CALL NO. 102
CONTRACT ID NO. 121001
ADDENDUM # 2

Subject: Pike County, APD 0806 (040)
Letting January 27, 2012

- (1) Revised - Plan Sheets - T1, T56, T57, & T58
- (2) Revised - Bid Items - Pages 84-88 of 88

DATE: Oct, 2010	CHECKED BY:
DESIGNED BY: Standard Sheet E. Kilgore	
DETAILED BY:	
Commonwealth of Kentucky DEPARTMENT OF HIGHWAYS	
PIKE	
ROUTE: US 460	ITEM NUMBER: 12-263.49
50'-70' OVERHEAD SIGN SUPPORT	
PREPARED BY: Division of Structural Design	SHEET NO. T057
	DRAWING NO.

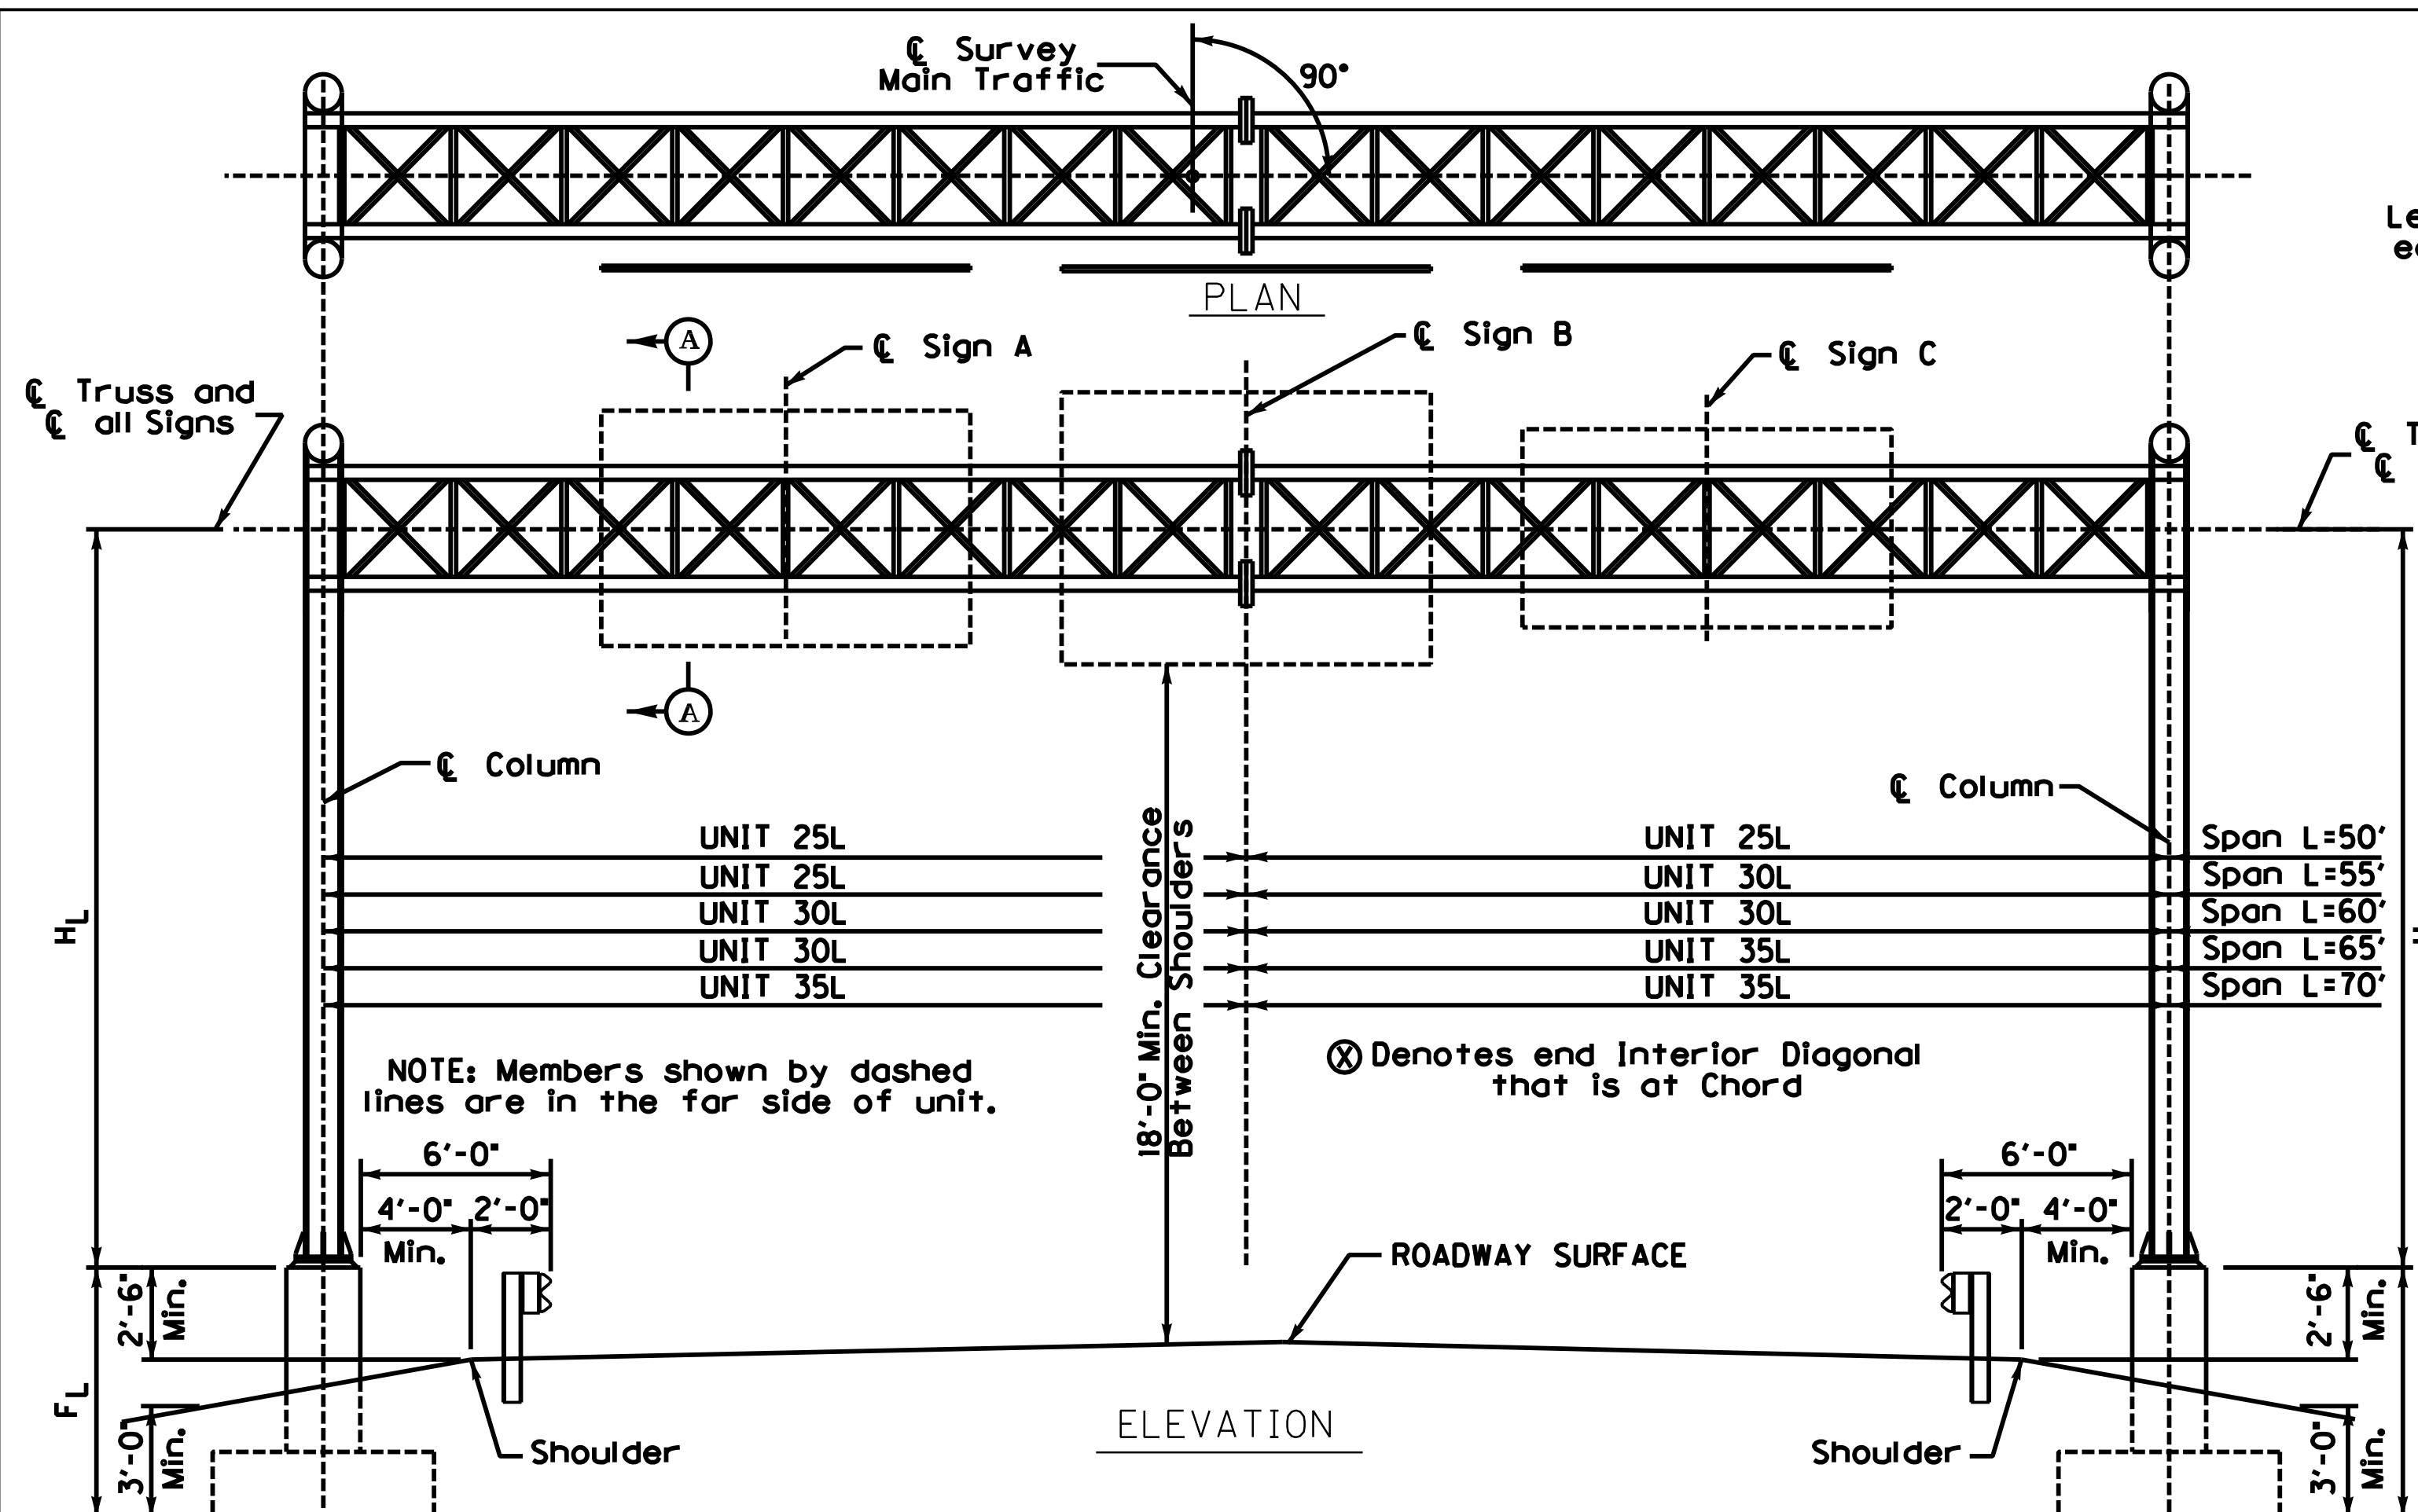
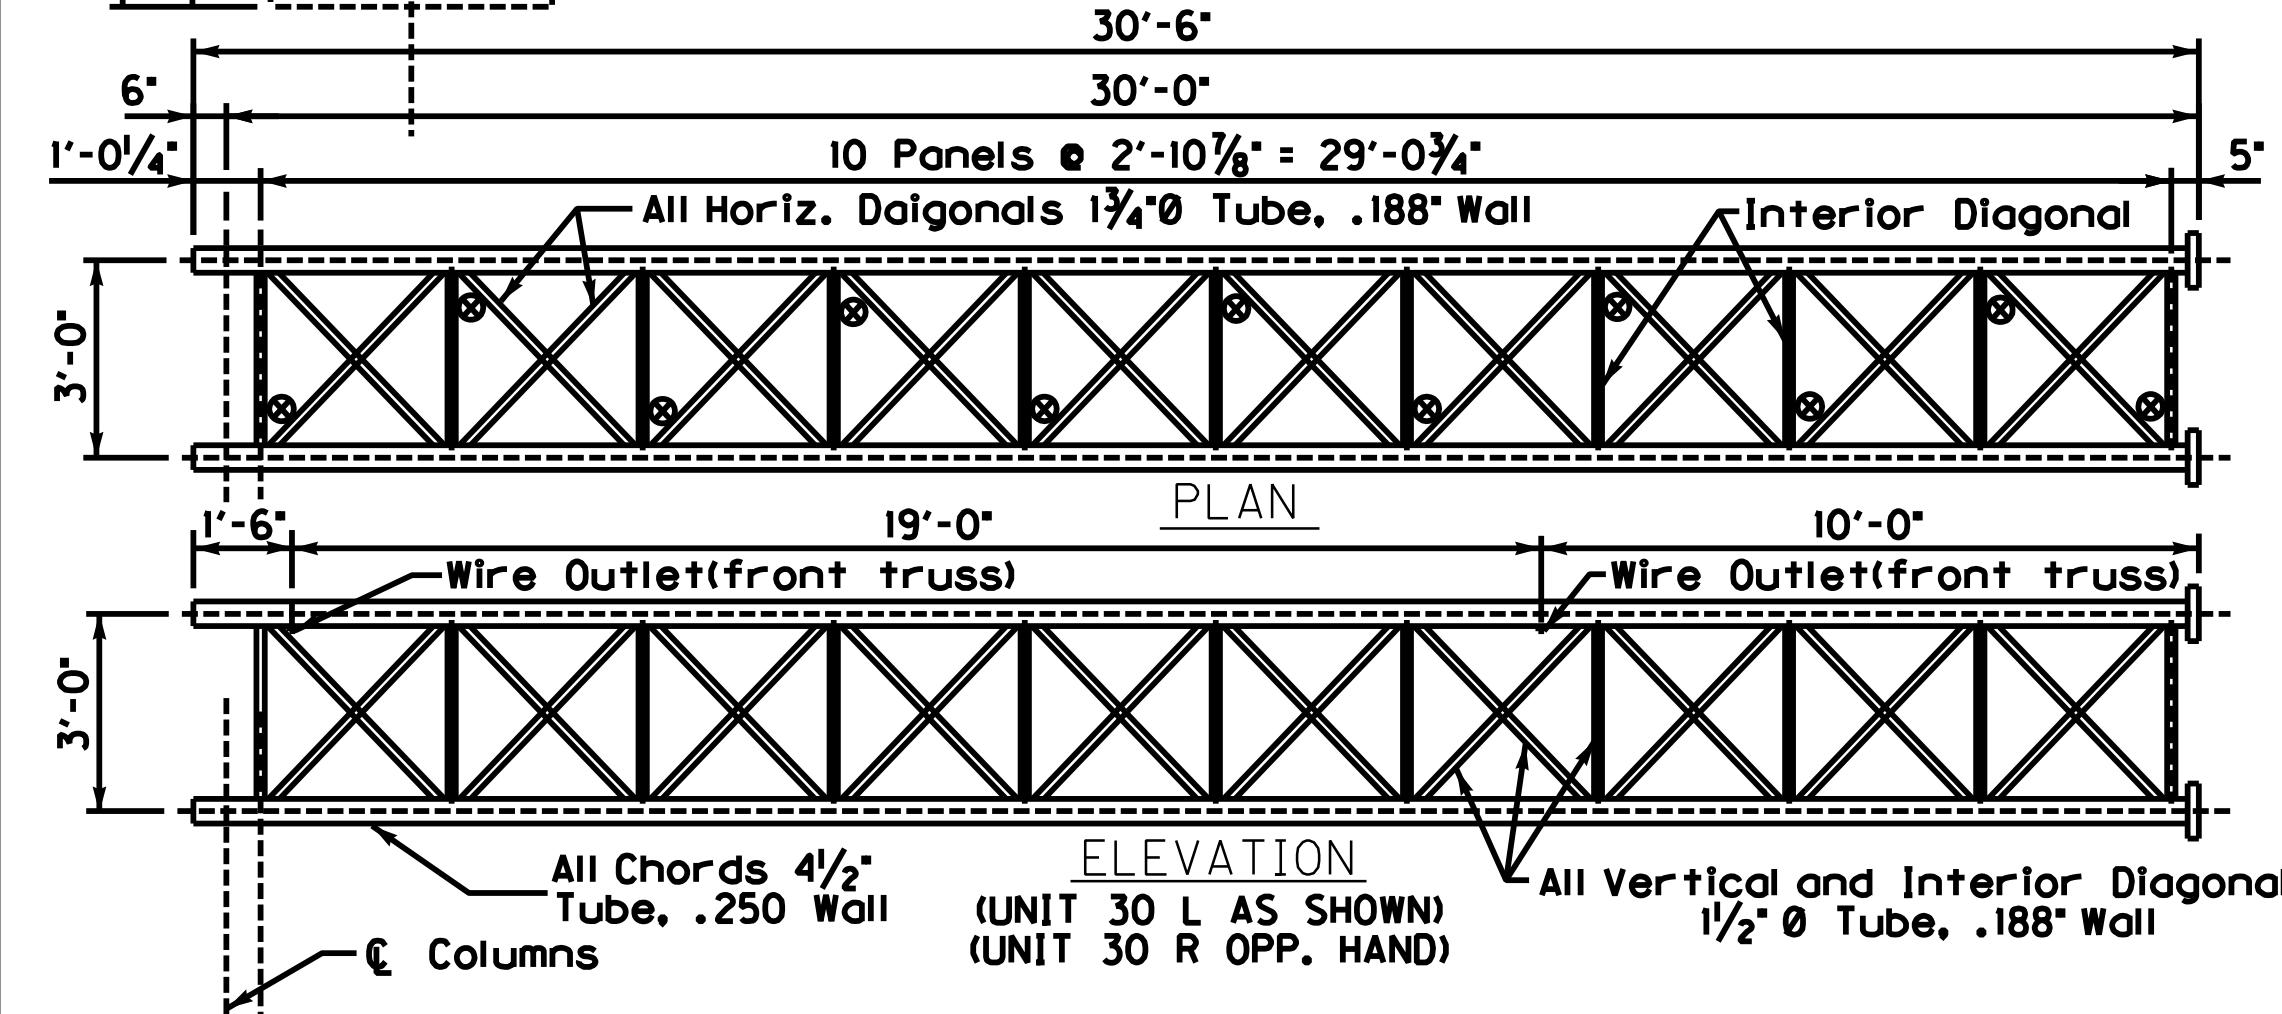
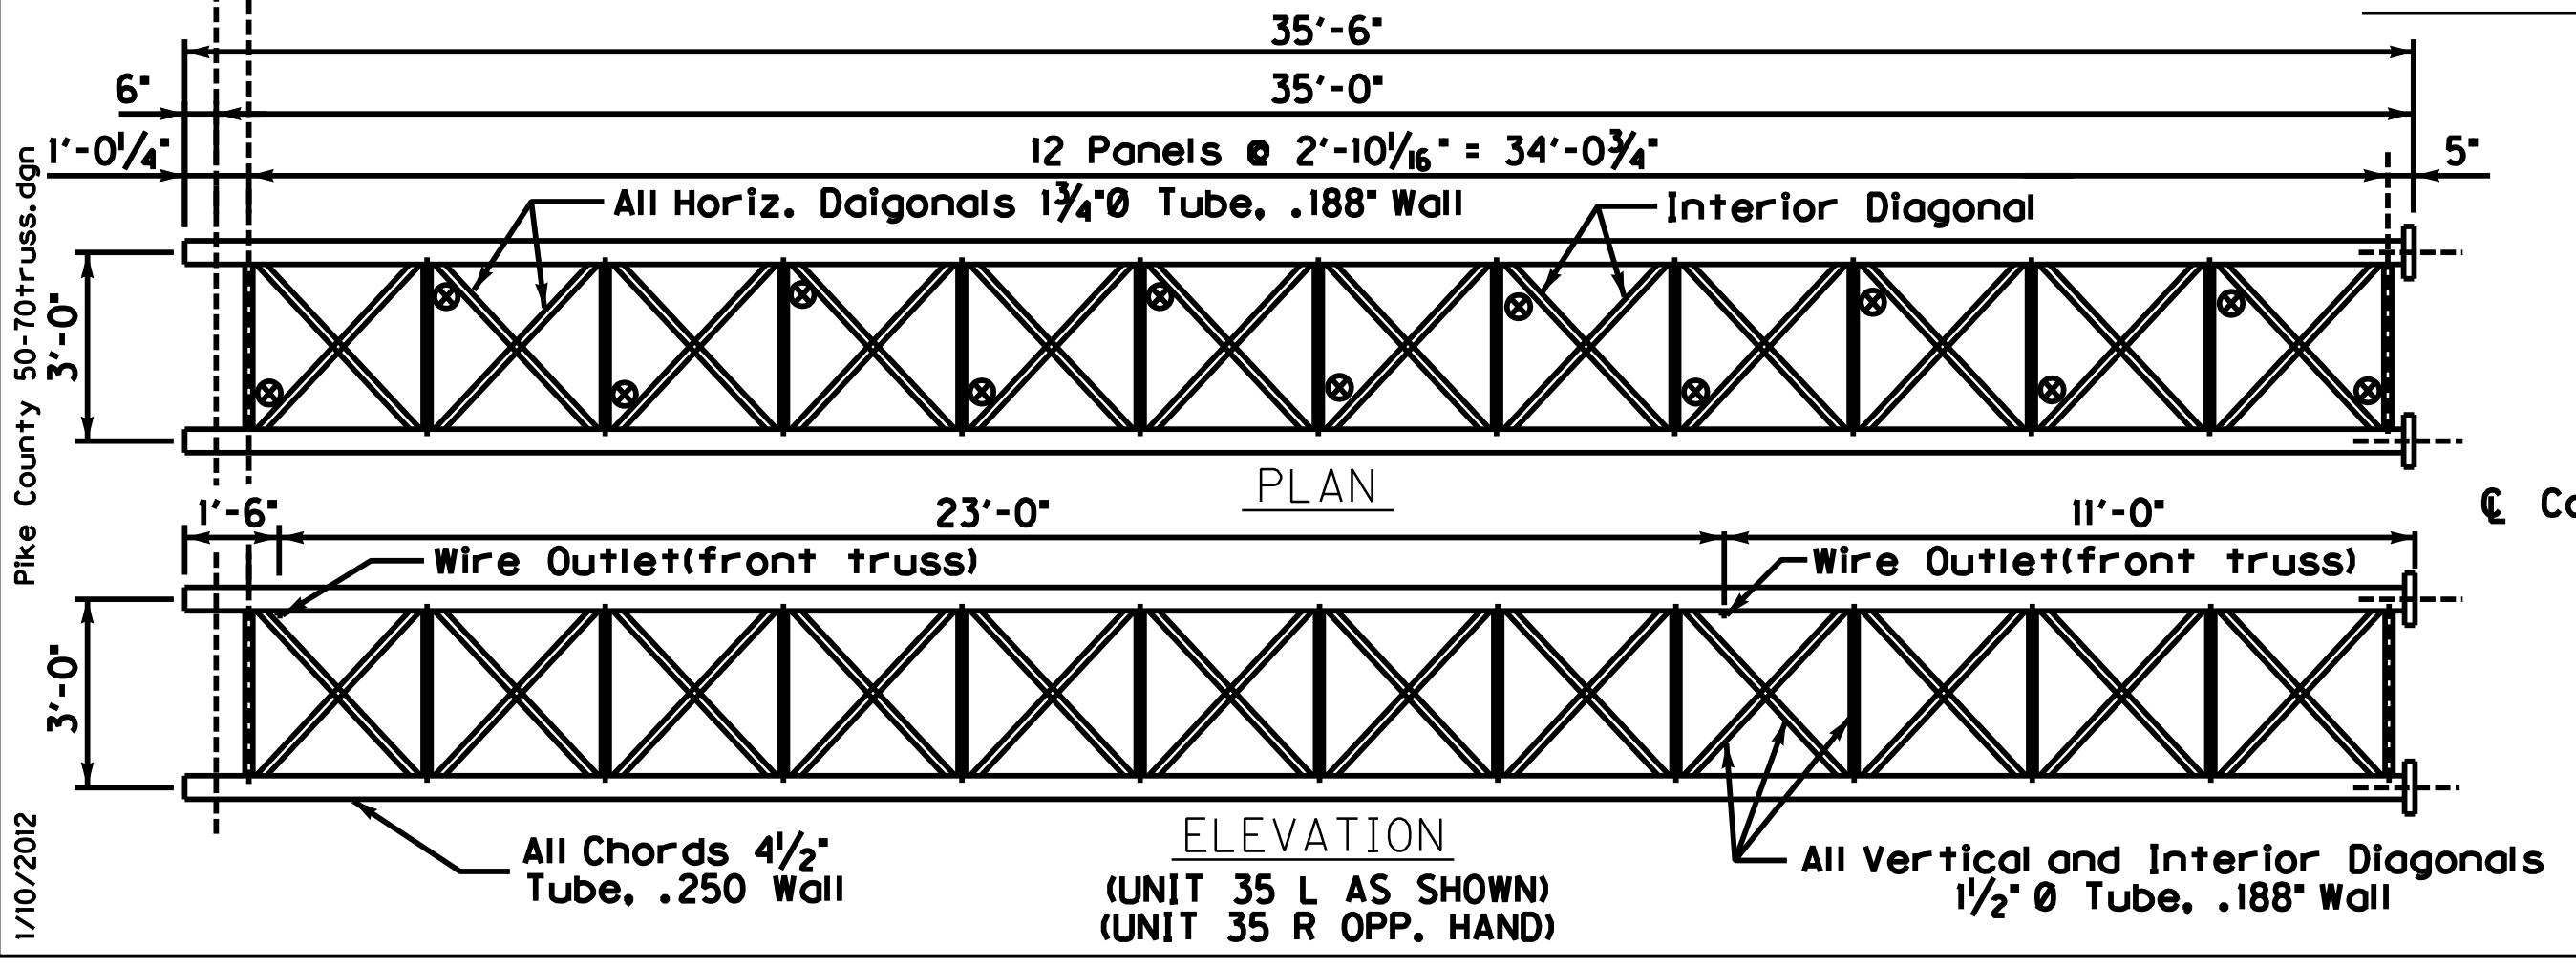
STA. 1+160
NOTE: SIGN TRUSS FOUNDATION DATA (UP TO BASE PLATE) FOR INFORMATION ONLY. SUPERSTRUCTURE TO BE CONSTRUCTED UNDER THIS PROJECT.

1 MODIFIED NOTE
